Technical Service Information

THM 3T40 (125C) 1988 - 1989 NO SECOND GEAR

Figure 1

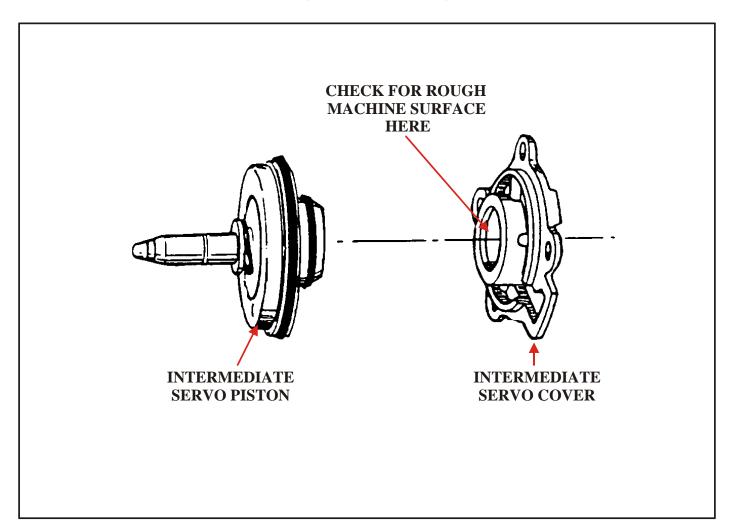
COMPLAINT: No second gear, manual or automatic, 1-3 shift only.

CAUSE: The cause may be a worn or torn lip seal (Small) on the intermediate servo piston, and created

by a rough surface machine finish in the bore of the intermediate servo cover (See Figure 1).

This rough finish will wear the lip off the (Small) intermediate servo seal.

CORRECTION: Replace the intermediate servo cover and intermediate servo piston lip seals.
